**PLANNED UNIT DEVELOPMENT
STAFF REPORT****Date: January 3, 2013****DEVELOPMENT NAME**

KMH, LLC

Planned Unit Development Approval to allow shared access and parking between multiple building sites.

SITE PLAN

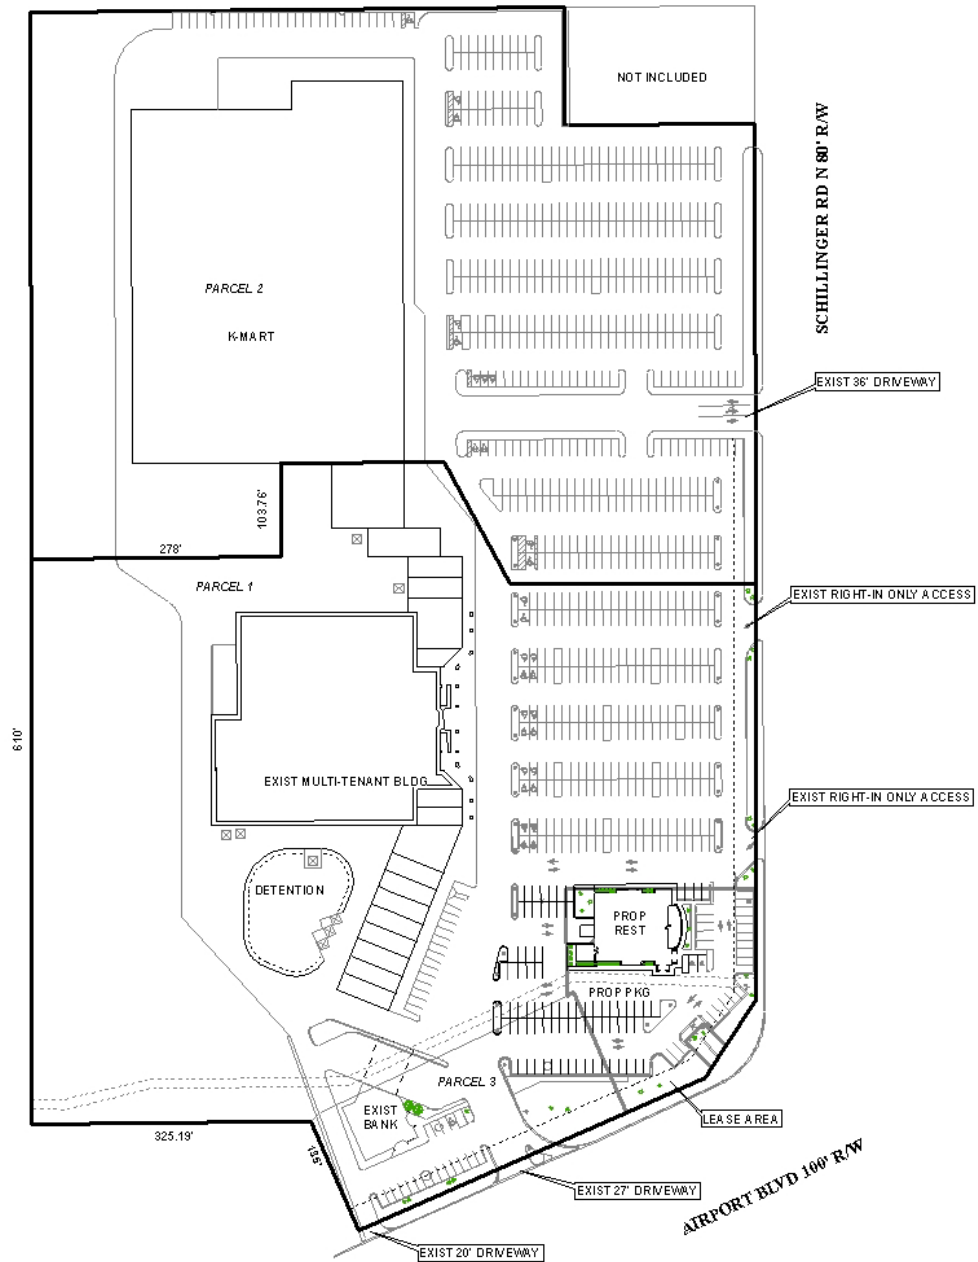
Driveway number, size, location and design to be approved by Traffic Engineering and conform to AASHTO standards. The “existing right in only” driveway on Schillinger Road nearest the restaurant site should be closed. There are no physical restrictions to keep this driveway from acting like a full-access driveway. In addition, there is an increased potential for high speed “slip ramp” type operation conflicting with vehicular and pedestrian movements around the restaurant. Closing this driveway will also allow for a smoother transition or taper in the aisle that is being created as a result of the additional spaces between the building and the right-of-way.

Traffic Engineering recommends that the existing right-in only entry from Schillinger Road South, nearest the restaurant site, be eliminated in order to minimize traffic conflicts. While this may be considered inconvenient for the applicant, it will reduce danger to future restaurant patrons as they park and walk to and from the restaurant.

No information was provided regarding the amount of existing/proposed landscape areas or trees. Existing palm trees are depicted on the site plan, however, the frontage area of the lease parcel should provide a total of 10 frontage trees, thus 4 additional trees (ideally palm trees to match existing palm trees) should be provided within the frontage area of the lease parcel.

No application for sidewalk waiver was submitted with the PUD application. The site plan indicates that there is limited room available for a sidewalk, especially along the Schillinger Road South frontage. As there are no existing sidewalks around this intersection, the requirement of sidewalks at this time may be unreasonable. Any future application for Subdivision of this site should take into consideration that sidewalks may be required at that time.

- 1) Revision of the minimum building setback line along Schillinger Road South to reflect future dedication sufficient for a 100-foot wide right-of-way;

- 2) Compliance with Traffic Engineering comments (*Driveway number, size, location and design to be approved by Traffic Engineering and conform to AASHTO standards. The "existing right in only" driveway on Schillinger Road nearest the restaurant site should be closed. There are no physical restrictions to keep this driveway from acting like a full-access driveway. In addition, there is an increased potential for high speed "slip ramp" type operation conflicting with vehicular and pedestrian movements around the restaurant. Closing this driveway will also allow for a smoother transition or taper in the aisle that is being created as a result of the additional spaces between the building and the right-of-way.*);

- 5) Provision of 4 additional frontage trees within the front setback area, to match existing trees in this area; and
 - 6) Full compliance with all other municipal codes and ordinances, with the exception of the requirement of a sidewalk.
